# UNITED STATES PATENT AND TRADEMARK OFFICE

APPLICATION NO.	FILING DATE	FIRST NAMED INVENTOR	ATTORNEY DOCKET NO.	CONFIRMATION NO.
10/780,337	02/17/2004	Dan Colvin	81044290	1104
22844	7590	10/03/2005		
FORD GLOBAL TECHNOLOGIES, LLC. SUITE 600 - PARKLANE TOWERS EAST ONE PARKLANE BLVD. DEARBORN, MI 48126			EXAMINER WRIGHT, DIRK	
			ART UNIT	PAPER NUMBER
			3681

***Examiner's Amendment***

Figure 3

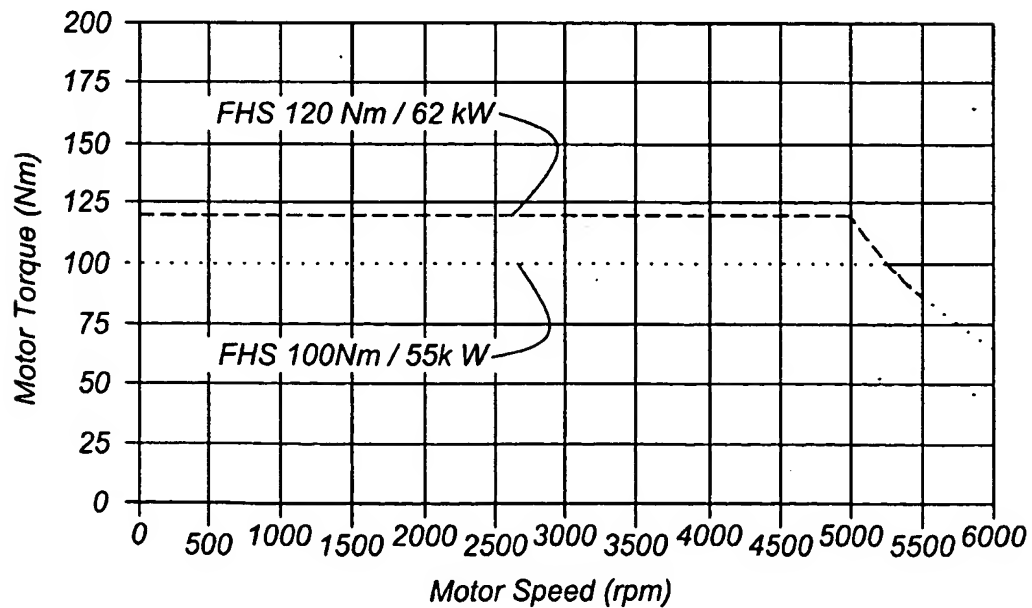
The following changes to the drawings have been approved by the examiner and agreed upon by applicant: In figure 2, "FO" must be changed to "FC", and a line must be added between shaft 22 and the unlabeled member connecting clutches DC and FC. In figure 3, "26" must be changed to "20". See the attached two sheets of marked up drawings indicating the above changes. New formal drawings incorporating these changes are now required.

Gear	40	28	<del>26</del>	38	2/4 Band
1st		X		X	
2nd		X			X
3rd		X	X		
4th			X		X
REV	X			X

20
